Your Ref: SSD-15882721

**Comments on Doran Drive Plaza Precinct
LOT 55 in DP 1253217**

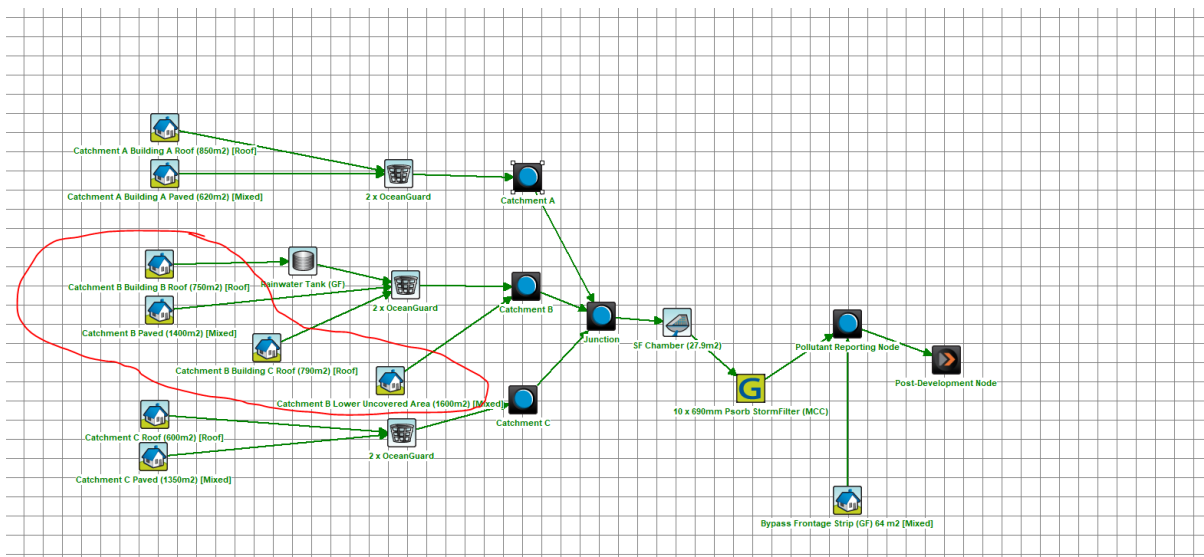
1. Being located near the top end of the catchment, the site will only be subject to potential overland flooding from an external catchment east of Andalusian Way. Being bounded along all sides by roads, overland flows will be captured and conveyed via the road network. We note based on Council's available flood mapping, the subject property is outside the 1% AEP Flood Extents of the nearby Cattai Creek.
